Department of Planning and Zoning

TO: Development Review Board
FROM: Scott Gustin & Mary O'Neil *msneil*
DATE: October 21, 2014
RE: 15-0338PD 112-114 Archibald Street
15-0341PD 27 Bright Street
15-0342PD 35-39 Bright Street
15-0343PD 47 Bright Street

Request: Final plat review of major Planned Unit Development for 44 dwelling units and associated site infrastructure and demolition of existing buildings.

PROPOSED SITE PLAN

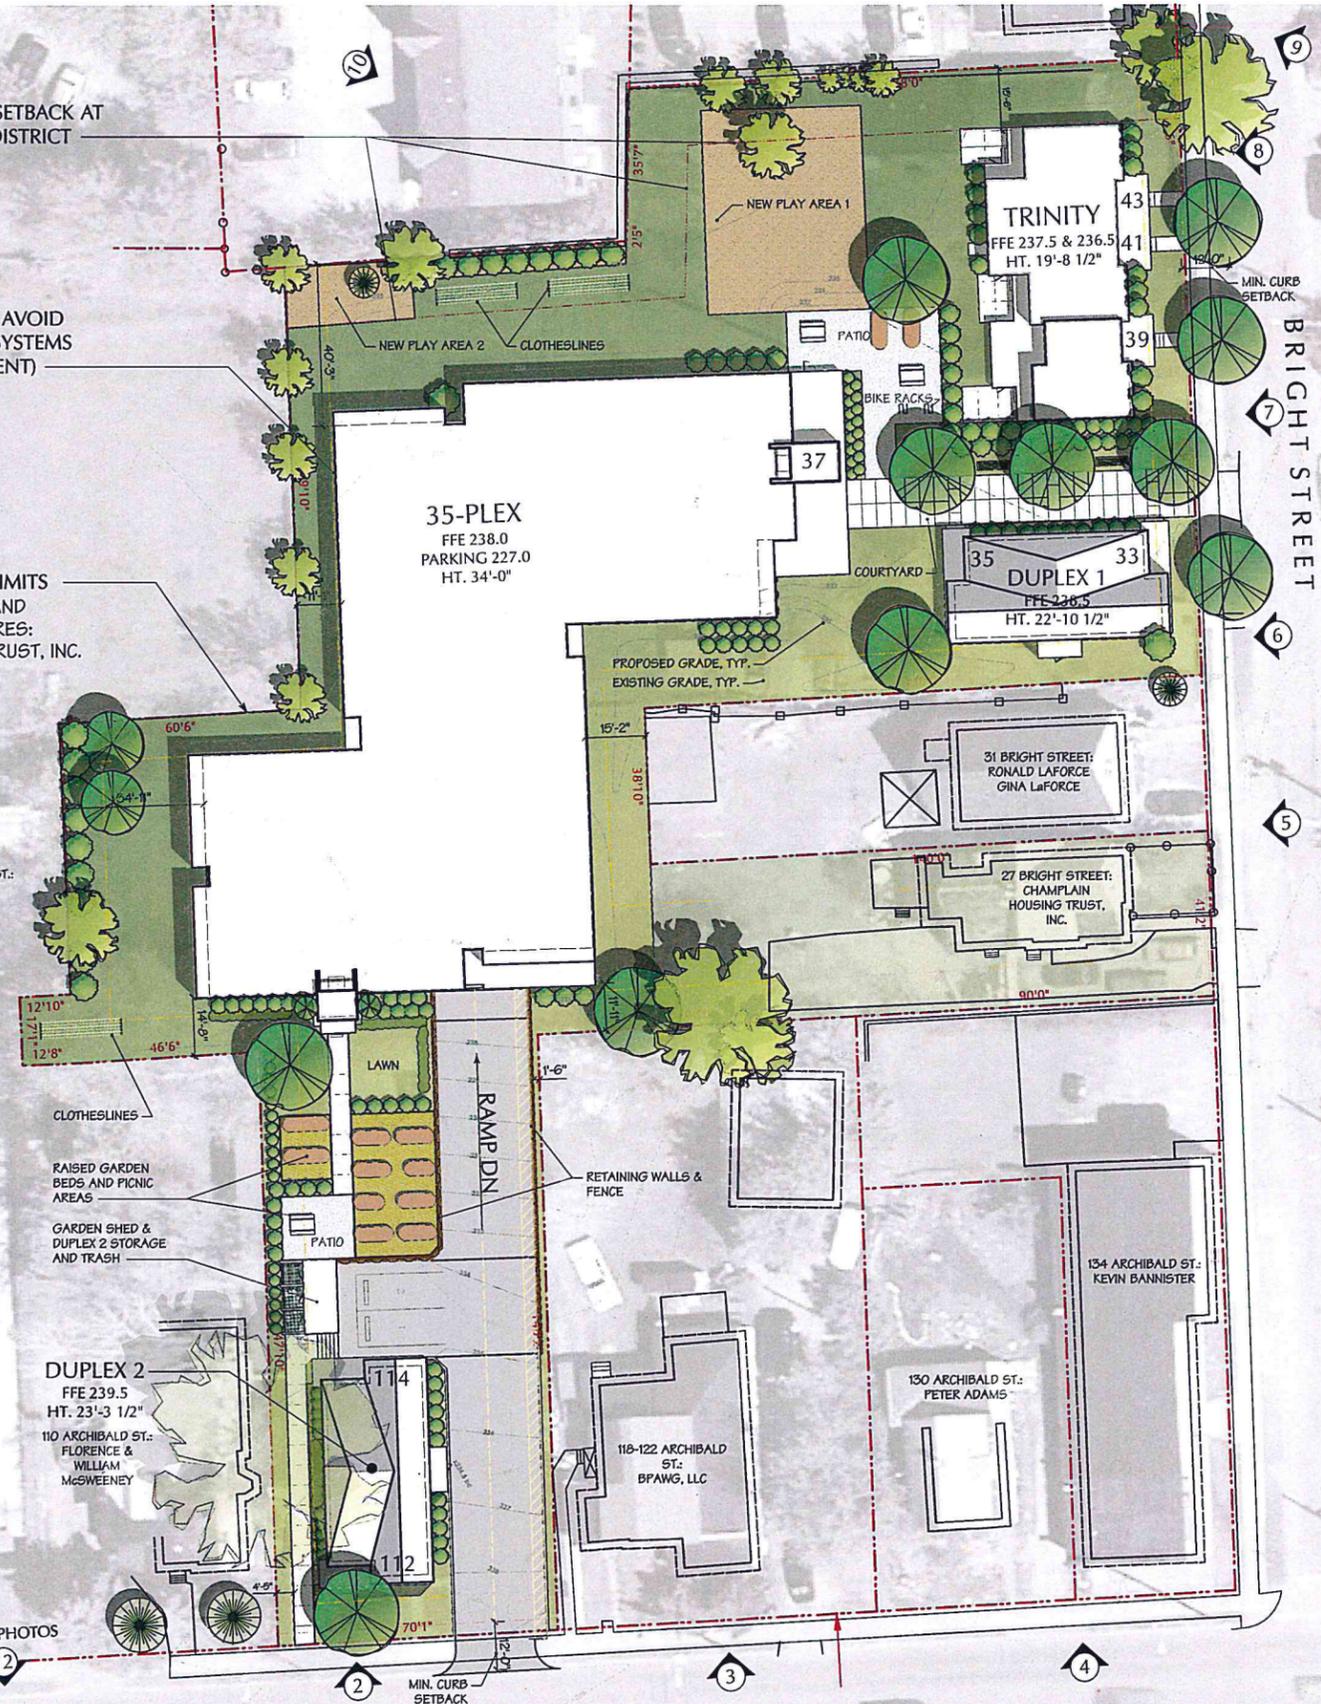
Only two setbacks apply to the NMU portion of the proposed development: 1) a 10' setback from the street curb and a 15' district setback along the NMU/RM boundary. The site plans depict acceptable street curb setbacks and also depict the 15' district boundary setback along the NMU/RM boundary to the north.

Filename: C:\Users\brittany.jynch\Desktop\Bright Street Cooperative Layout 040114F.AGI

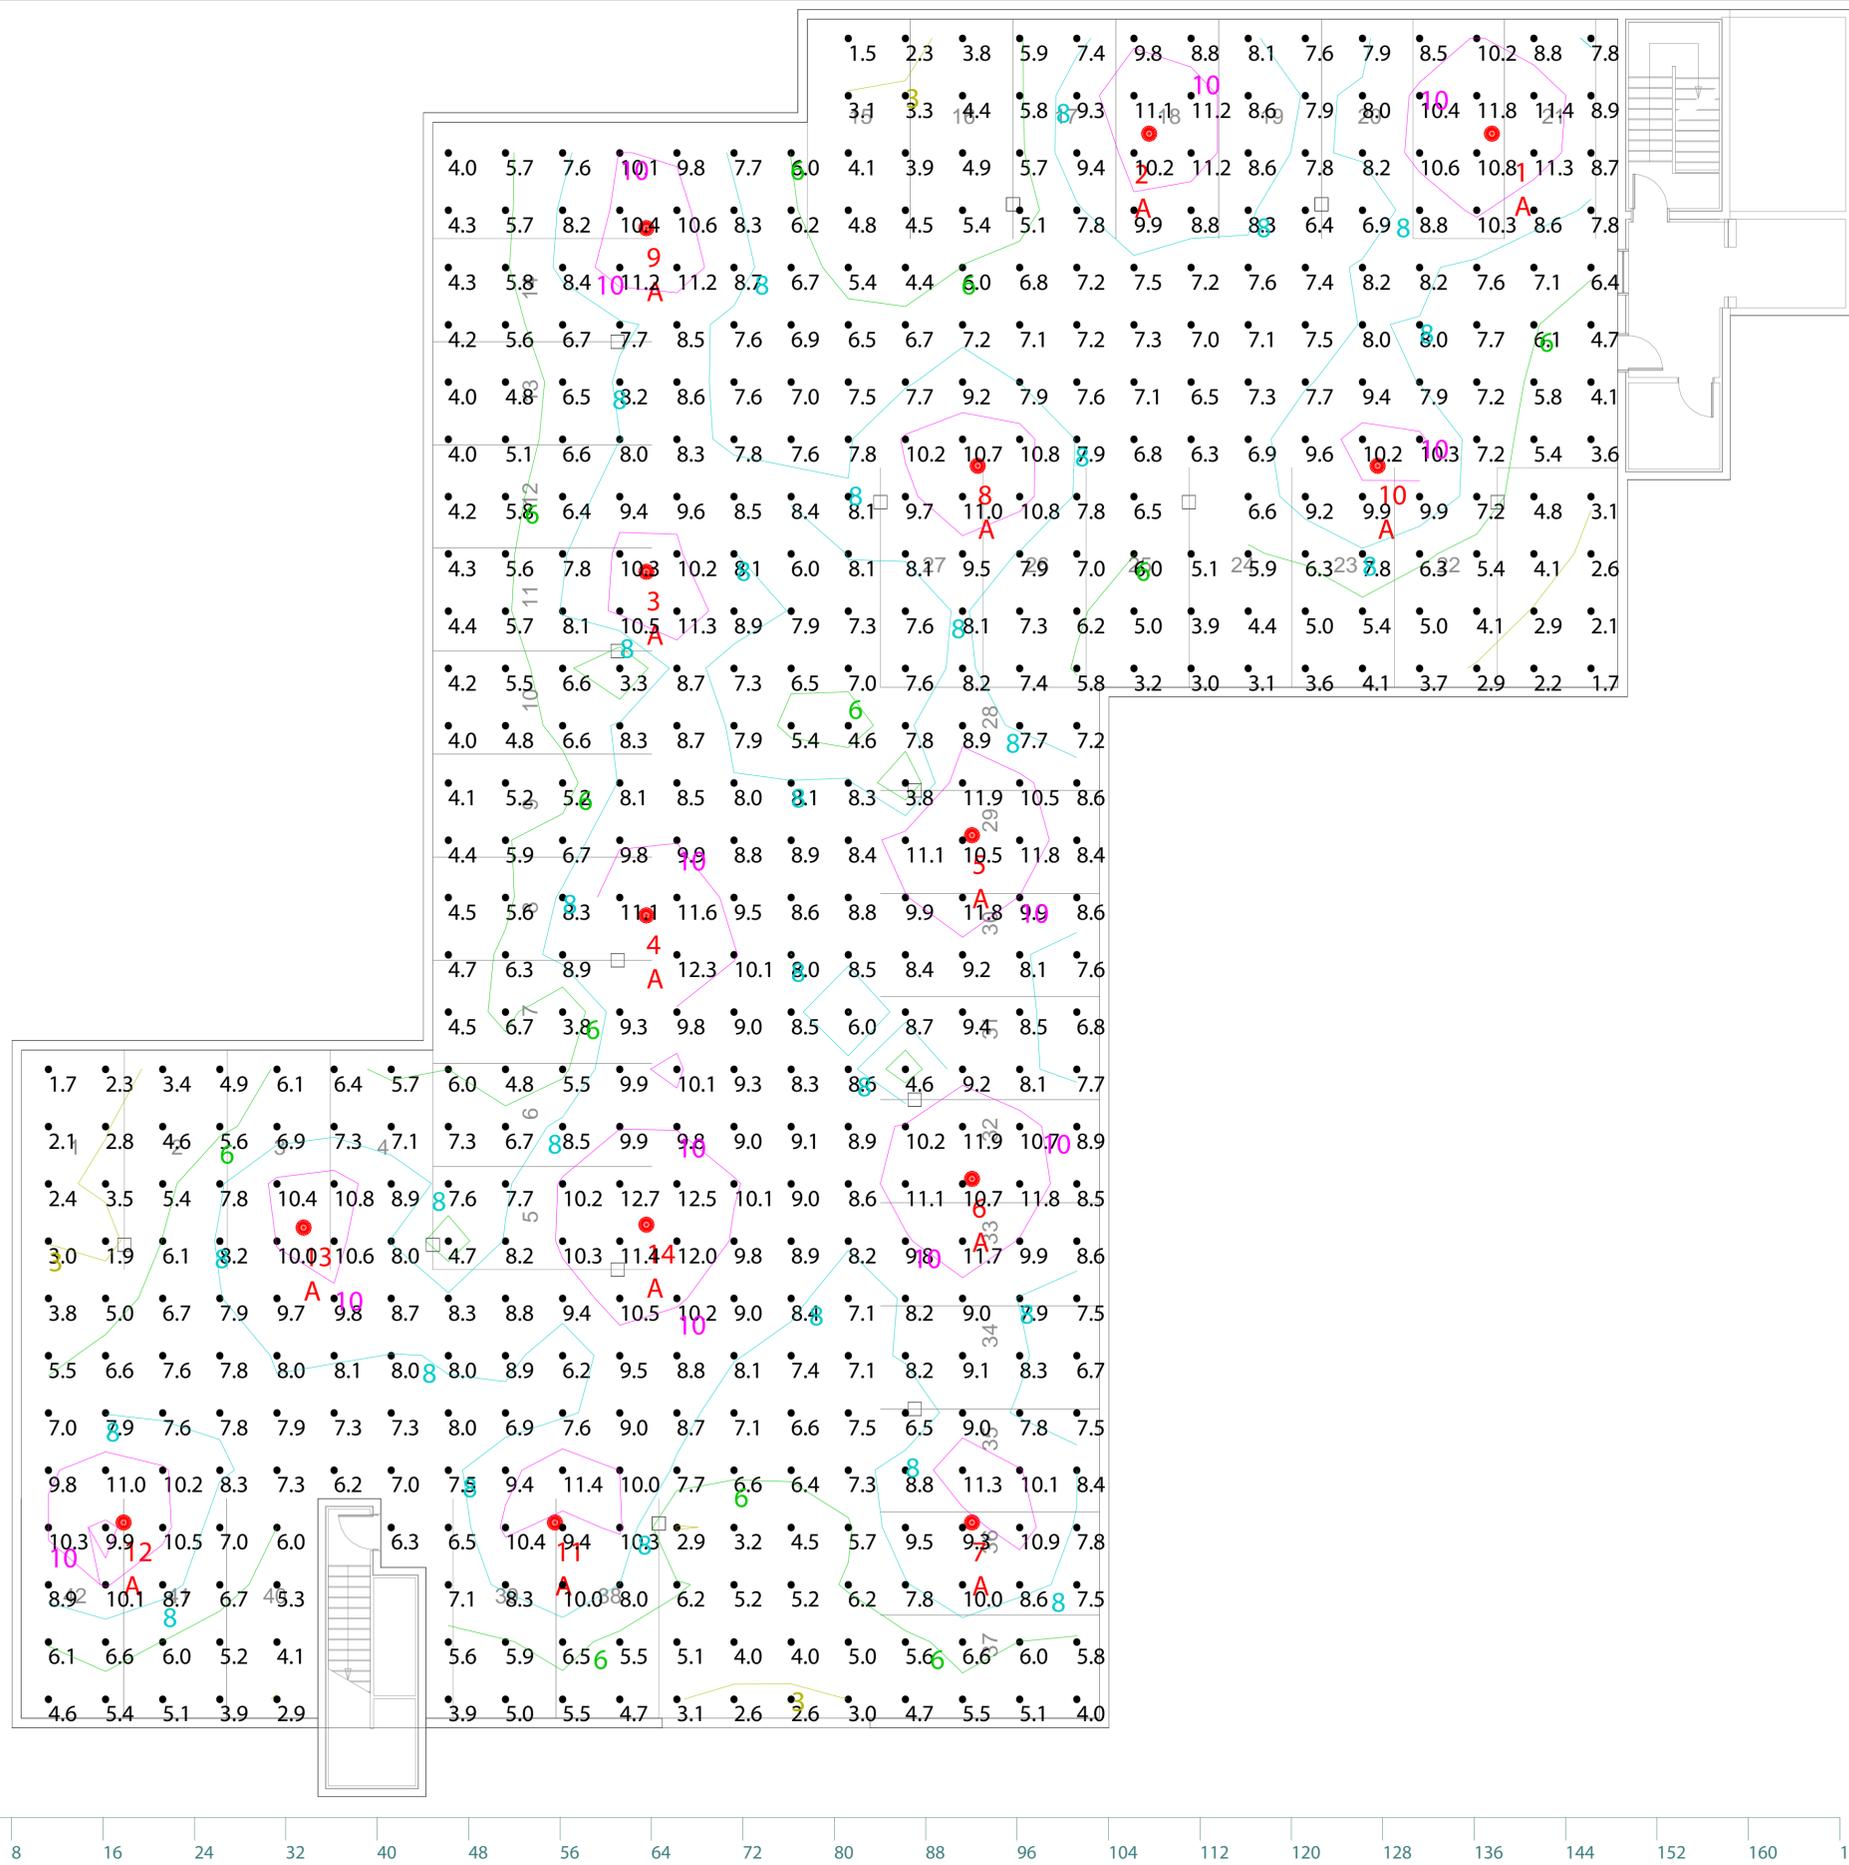
3. Lighting at building entrances exceeds standards of the *Outdoor Lighting Manual for Vermont Municipalities*, Table 2, p. 10: *Building Entry – active use, 5 footcandles average maintained*. Measurements on the lighting plan illustrate entryway lighting between 5.1 fc (duplex 2 on Archibald Street) to 8.7 fc (Trinity east entrance.) All building entrances exceed the 5 footcandle limitation, and will require revision to meet these standards, or confirmation that the average maintained level meets the standard.

Lighting at building entrances has been revised downward; however, illumination levels at several building entries exceed the 5.0 footcandle maximum noted in the *Outdoor Lighting Manual for Vermont Municipalities*, Table 2, p. 10: *Building Entry – active use, 5 footcandles average maintained*. Entryway lighting must be revised so as to not exceed this 5.0 footcandle maximum

5. **Prior to release of the zoning permit**, a revised photometric plan shall be submitted that depicts illumination levels of 5.0 footcandles or less at all building entries (not including the underground garage), subject to staff review and approval.

Job Name:
Bright Street Garage
Burlington, VT
Lighting Layout
Version B

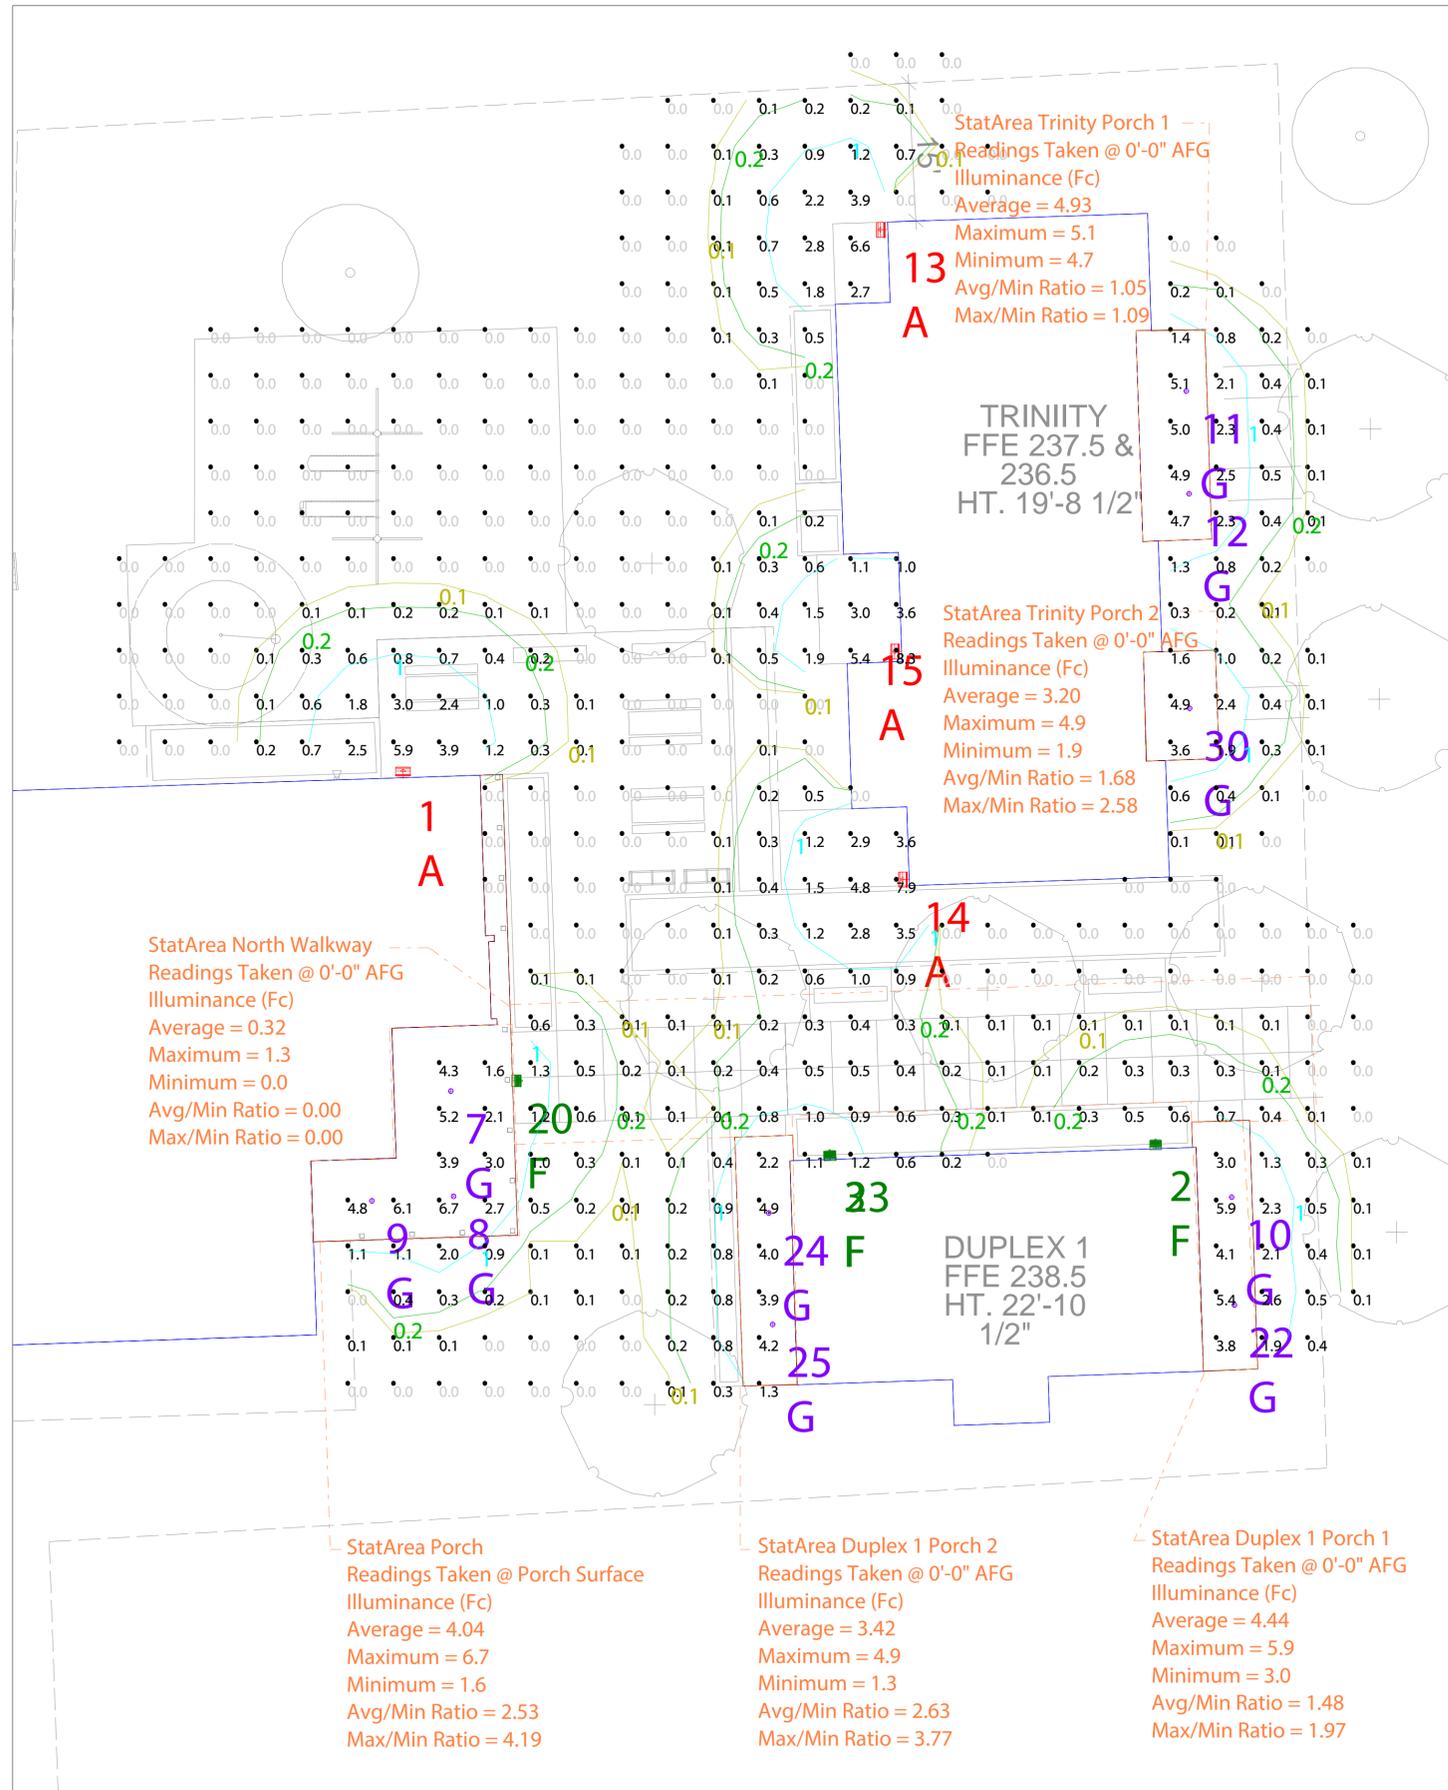
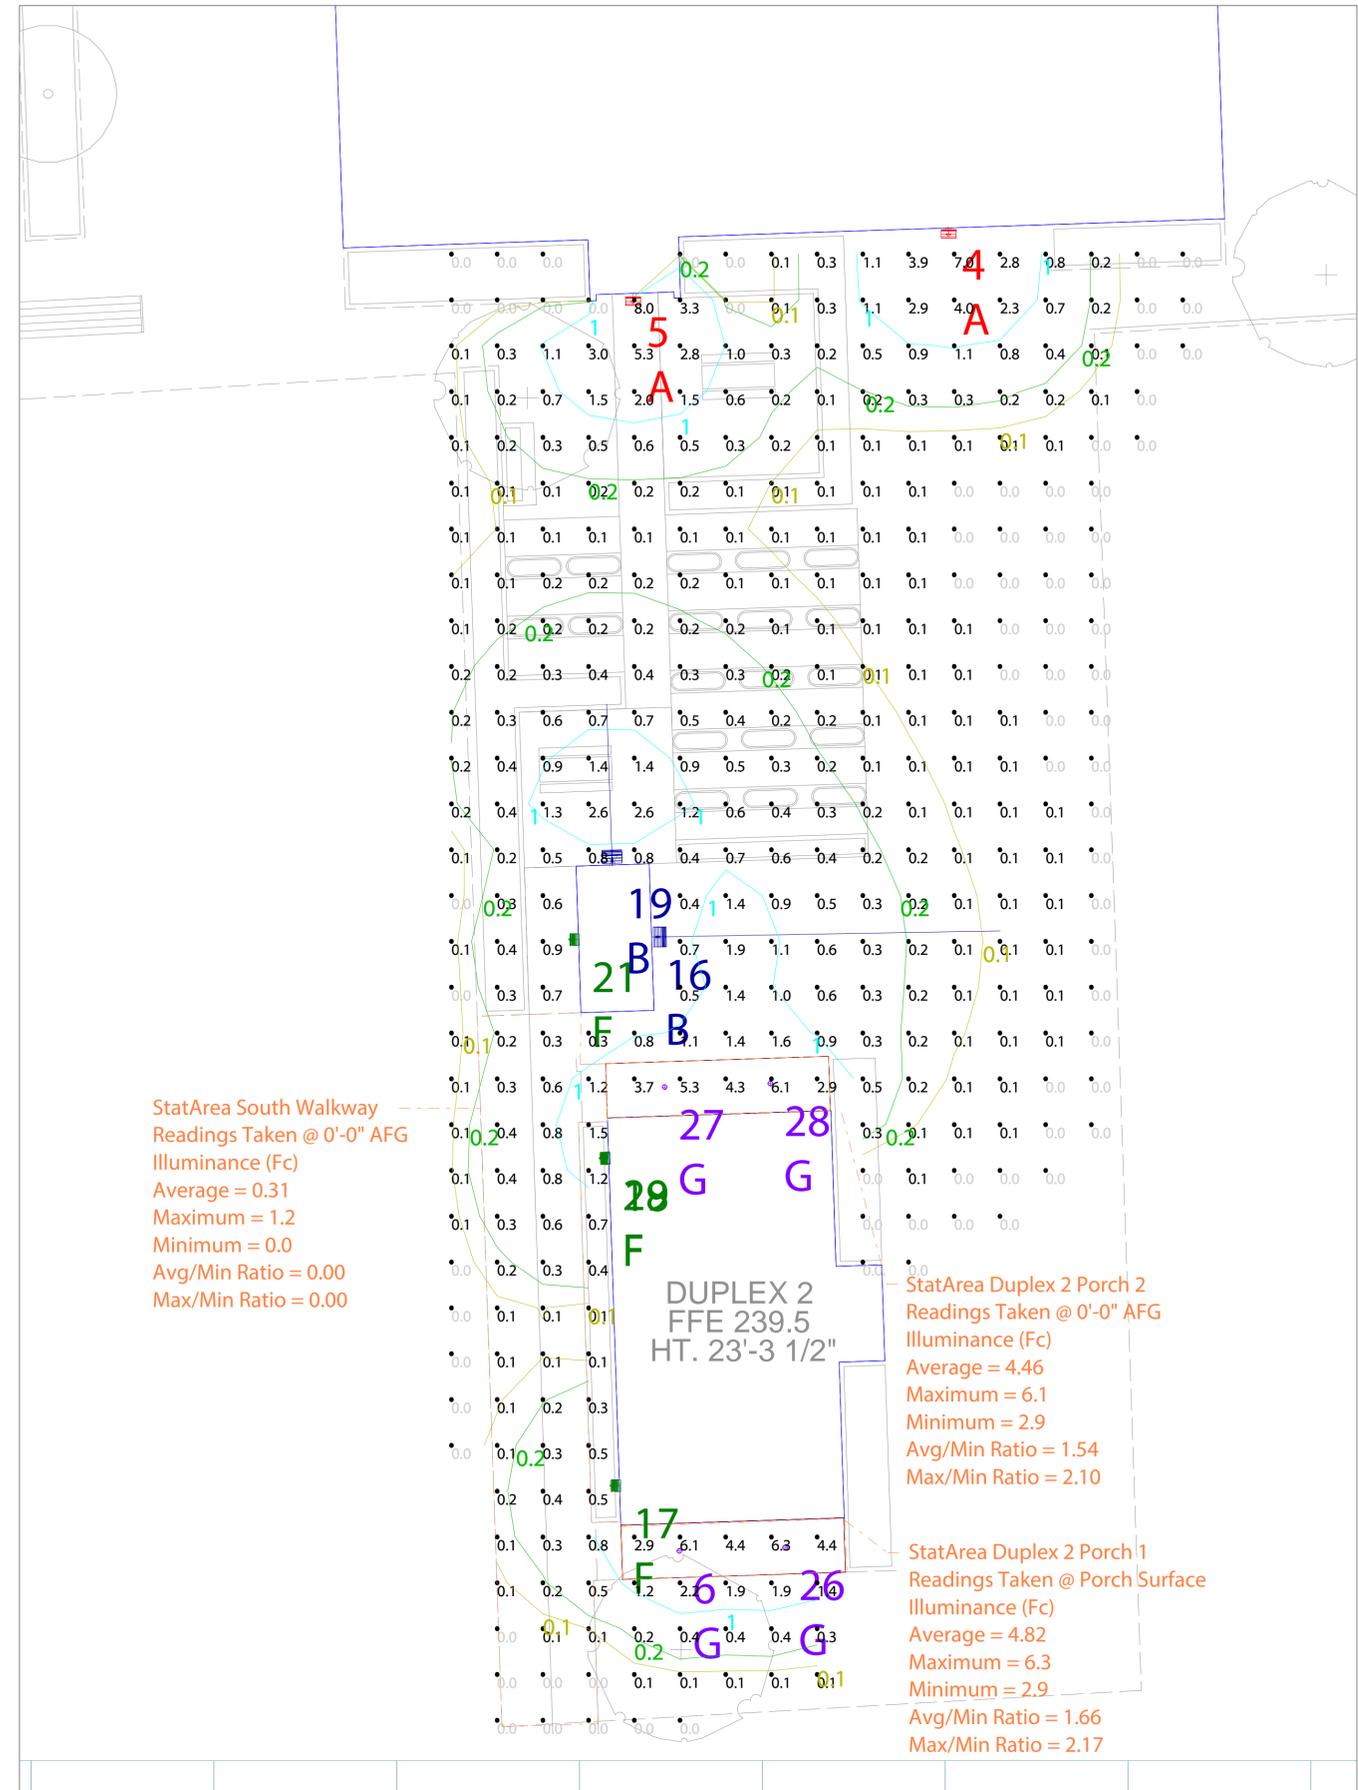
2. **Prior to release of the zoning permit**, confirmation that the parking garage lighting plan conforms to RP-20-98 as determined by their lighting design consultant, as required by Sec. 5.5.2 (f) 5 must be submitted to staff. Any garage lighting fixture visible from the exterior of the garage facility shall be shielded in a manner that prevents glare to be visible from the exterior of the parking garage.

2. Garage lighting plan is stamped and signed by Engineering Services of Vermont, it is found to be in compliance with the parking garage lighting ordinance and IESNA document RP-20-98.
3. The building entrance lighting has been dimmed and all averages have been noted to comply with the Outdoor Lighting Manual for Vermont Municipalities.
5. Proposed design and construction details for retaining walls and associated guardrails (Item 8) will be provided prior to the release of the permit.
6. The HVAC equipment proposed for the rooftop of the 35-Plex will be two ERU units to be located behind the stair tower and the elevator tower as shown in plan on sheet 1.0 Architectural Site Plan and in 5.1 & 5.2 35-Plex elevations revised and attached.
